ISSUE: Permit to Demolish/Capsulate (partial) and Certificate of Appropriateness for alterations

APPLICANT: Capital One N A

LOCATION: Old and Historic Alexandria District
500 South Washington Street

STAFF RECOMMENDATION

Figure 2 - west elevations view, not visible from Washington Street

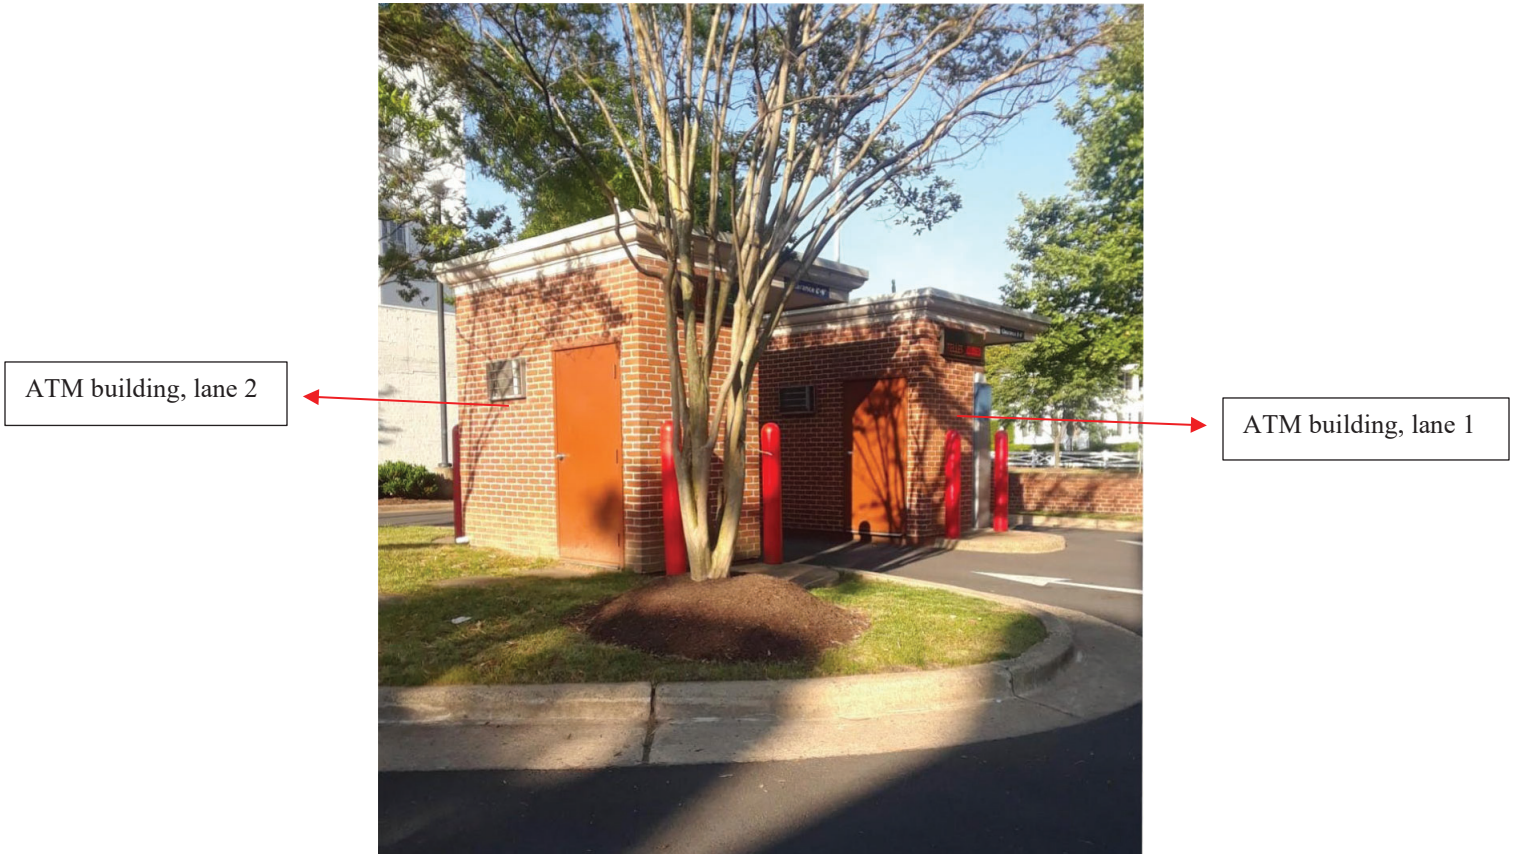
wall will be patched with new brick veneer to match existing. The west elevation is visible from Washington Street. A double door will be installed on the rear/east elevation, not visible from Washington Street (Figure 2), and the existing 24"x16" louver for mechanical unit will be relocated from the east/rear elevation to the south elevation wall, also not visible from Washington Street.
